**Proposal #33: Project ID 6933-00-76
Babcock - Nekoosa
CTH G (N) to STH 73
STH 173
Wood County**

This is Addendum No. 01, which provides for the following:

ADDENDUM NO. 01

Addendum No. 01
ID 6933-00-76
Revised Sheet 8
January 6, 2022

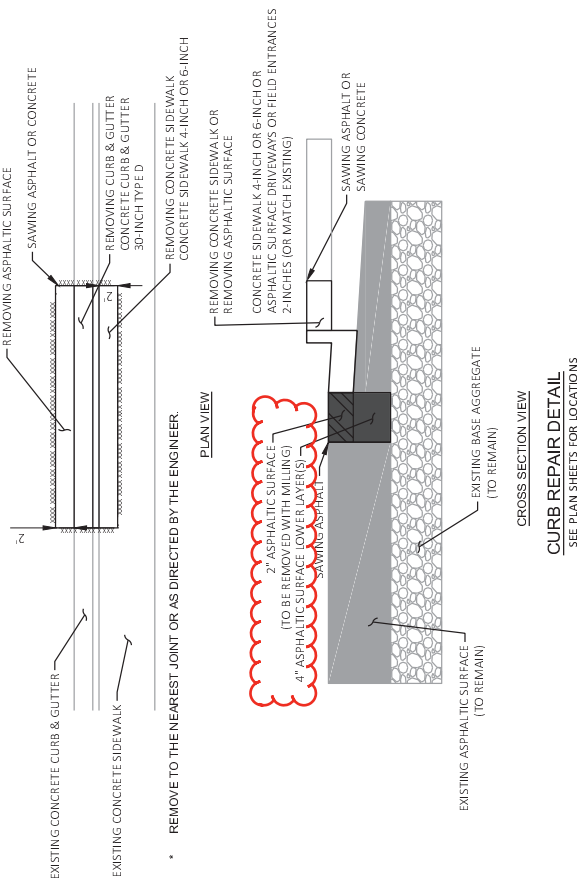
Revised Plan Sheets	
Plan Sheet	Plan Sheet Title (brief description of changes to sheet)
7	Typical Section: Modify lower layer pavement type for railroad approach pavement
8	Construction Detail: Modify lower layer pavement type for manhole and inlet removal and salvage detail and curb repair detail
86	Miscellaneous Quantities: Deleted bid item 460.6223 and revised quantity for bid item 465.0105
87	Miscellaneous Quantities: Changed bid item 460.6223 to bid item 465.0105

Furnish an asphaltic mixture meeting the requirements specified for an MT mix under 460.2 for the lower layer(s) of roadway pavement.
